Intersection ID: 44002	Main Street: REA_RD	Cross Street: SOUTHBROOK_DR	Location:	SW
ADA ID: 8E83B8DC9A94	Ramp Type: Perpendicular Diagonal	Initial Pass/Fail: Fail	Overall Compliance: No	Severity Score: 31.25

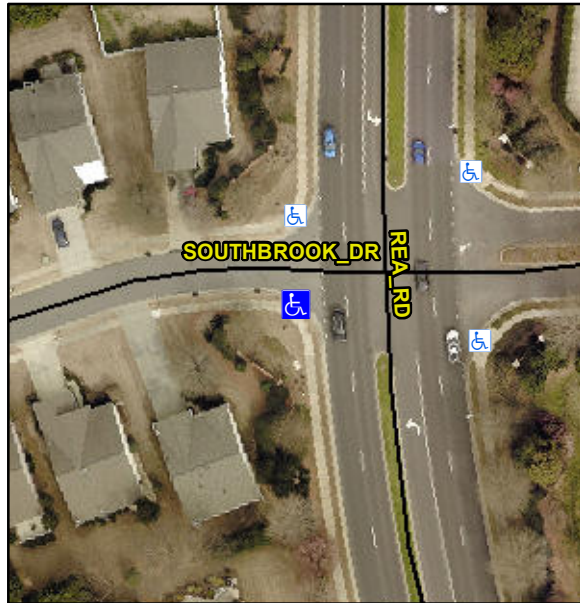
Surveyor Notes:

N/A

Compliance	Description	Data	Compliance	Description	Data
N/A	Ramp Length (in)	101.0	No	Ramp Slope (%)	11.3
No	Ramp Width (in)	32.0	No	Ramp XSlope (%)	3.1
N/A	Flare Type LT	N/A	N/A	Flare Type RT	N/A
N/A	Flare Slope LT (%)	N/A	N/A	Flare Slope RT (%)	N/A
N/A	Flare Traversable LT?	N/A	N/A	Flare Traversable RT?	N/A
N/A	Landing Length (in)	N/A	N/A	DWS Provided?	N/A
N/A	Landing Width (in)	N/A	N/A	DWS Contrast?	N/A
N/A	Landing Slope (%)	N/A	N/A	DWS Length (in)	N/A
N/A	Landing X Slope (%)	N/A	N/A	DWS Full Width?	N/A
N/A	Landing Curb? (Y/N)	N/A	N/A	DWS Offset (in)	N/A
N/A	Shared Landing?	N/A			
N/A	Gutter Ponding?	N/A	N/A	Gutter Slope (%)	N/A
N/A	Gutter Lip Ht (in)	N/A	N/A	Gutter X Slope (%)	N/A
N/A	Painted X Walk1?	No	N/A	Painted X Walk2?	No
	X Walk 1 Direction	To SE		X Walk 2 Direction	To NE
N/A	X Walk 1 Width (in)	N/A	N/A	X Walk 2 Width (in)	N/A
	X Walk 1 Slope (%)	1.3		X Walk 2 Slope (%)	0.6
	X Walk 1 X Slope (%)	0.8		X Walk 2 X Slope (%)	0.7

Remove & Replace Curb Ramp With Two New Directional Ramps or Equivalent.
